DRAWING NO. D206-667-147	TITLE CROSSTUBE ASS'Y (206L MID FWD)	REV. A	DART AEROSPACE LTD ENGINEERING ORDER		D.E.O. NO. D206-667-147-A-1	SHEET NO. SHEET 1 OF 1	SCALE NTS
DRAWN <i>q</i>	CHECKED <i>ASS</i>	MFG. APPR. <i>AS</i>	APPROVED <i>MD</i>		DE APPR. <i>th</i>		
DATE 11.07.15	DATE 11.07.20	DATE 11.07.21	DATE 11/07/21		DATE 11.07.21

PURPOSE:

REPLACE MAGNOBOND WITH PROSEAL.

DRAWING NO. D206-667-147		TITLE CROSSTUBE ASS'Y (206L MID FWD)		REV. A	DART AEROSPACE LTD ENGINEERING ORDER		D.E.O. NO. D206-667-147-A-2	SHEET NO. SHEET 1 OF 1	SCALE NTS
DRAWN AJS		CHECKED		MFG. APPR. <i>E</i>		APPROVED <i>NO</i>		DE APPR. <i>#</i>	
DATE 12.08.02		DATE 12.08.02		DATE 12.08.02		DATE 12.08.02		DATE 12.08.02

DETAIL P
BONDING STRAP INSTALLATION 2 PL

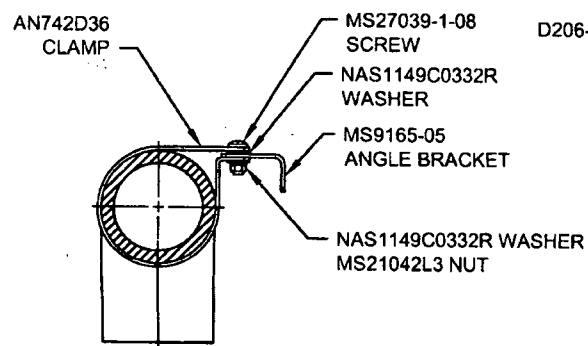
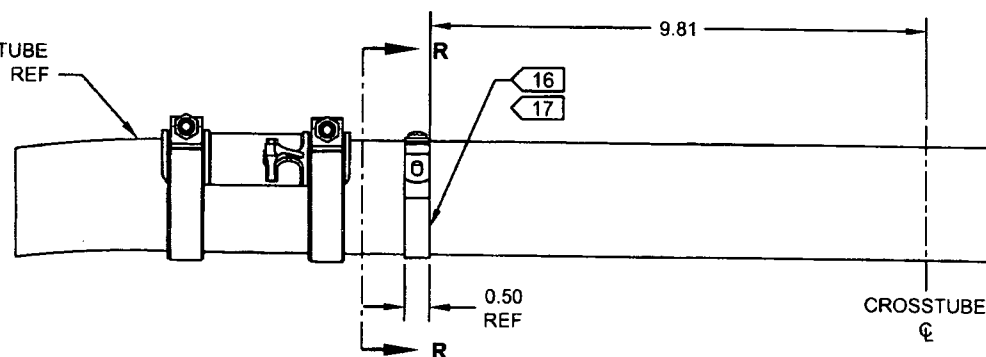
ADD ELECTRICAL GROUNDING STRAP

ITEM	QTY -147	PART NUMBER	DESCRIPTION
1	X	D206-667-147	CROSSTUBE ASSEMBLY (206L MID FWD)
⚡			
10	2	AN742D36	CLAMP
11	2	MS9165-05	ANGLE BRACKET
12	2	MS21042L3	NUT (OR MS21042-3)
13	2	MS27039-1-08	SCREW
14	4	NAS1149C0332R	WASHER (OR AN960C10L)

- 16) MASK AREA UNDER CLAMP PRIOR TO PAINTING
 17) SEAL EDGES WHERE AN742D36 CLAMP MEETS WITH THE CROSSTUBE USING SIKAFLEX-241/-291 OR MIL-S-8802 CLASS B2 OR PROSEAL 890 SEALANT
 18) PERFORM RESISTANCE CHECK TO ENSURE MAX RESISTANCE IS 10 MILLIOHMS
